**SUNDRY NOTICES AND REPORTS ON WELLS**  
Do not use this form for proposals to drill or to re-enter an abandoned well. Use form 3160-3 (APD) for such proposals.

8. Well Name and No.  
MALLON FEDERAL 30 043

9. API Well No.  
30-025-34448

TYPE OF SUBMISSION	TYPE OF	E-PERMITTING <SWD	INJECTION
<input checked="" type="checkbox"/> Notice of Intent	<input type="checkbox"/> Acidize	CONVERSION	RBDMS
<input type="checkbox"/> Subsequent Report	<input type="checkbox"/> Alter Casing	RETURN TO	TA
<input type="checkbox"/> Final Abandonment Notice	<input type="checkbox"/> Casing Repair	CSNG	CHG LOC
	<input type="checkbox"/> Change Plans	INT TO PA	P&A NR
	<input type="checkbox"/> Convert to Injection		P&A R
	<input type="checkbox"/> Deepen		
	<input type="checkbox"/> Fracture Treat		
	<input type="checkbox"/> New Construction		
	<input checked="" type="checkbox"/> Plug and Abandon		
	<input type="checkbox"/> Plug Back

MALLON 30' FED #3 43

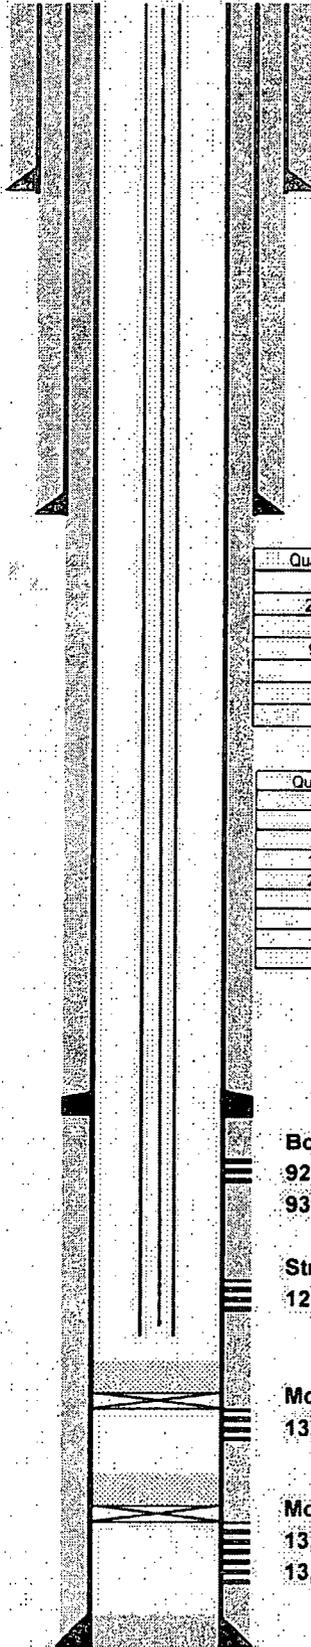
Drill out Cmt & CIAP @ 9145.

- 1) PUMP 35 SXS.CMT. @ 12,873'-12,653' (T/MISS.); WOC X TAG CMT. PLUG. *marked*
- 2) SET 5-1/2" CIBP @ 12,200'; DUMP BAIL 35' CMT. @ 12,200'-12,165'
- 3) PUMP 35 SXS.CMT. @ 11,185'-10,975' (T/STWN). *Add: spot plug from 10556-10356 (Top Wolfcamp)*

- 4) SET 5-1/2" CIBP @ 9,200'; PUMP 35 SXS.CMT. @ 9,200'-8,978' (DV TOOL); WOC X TAG
- 5) CIRC. WELL; PUMP 30 SXS.CMT. @ 8,288'-8,108' (T/B.S.); WOC X TAG CMT. PLUG. 7290-7120

- 6) PUMP 25 SXS.CMT. @ 5,724'-5,574' (T/DLWR.); WOC X TAG CMT. PLUG. 4749-4599
- 7) PUMP 25 SXS.CMT. @ 4,287'-4,147' (9-5/8" CSG SHOE); WOC X TAG CMT. PLUG.

*Below ground dry hole marker required (LFC)*
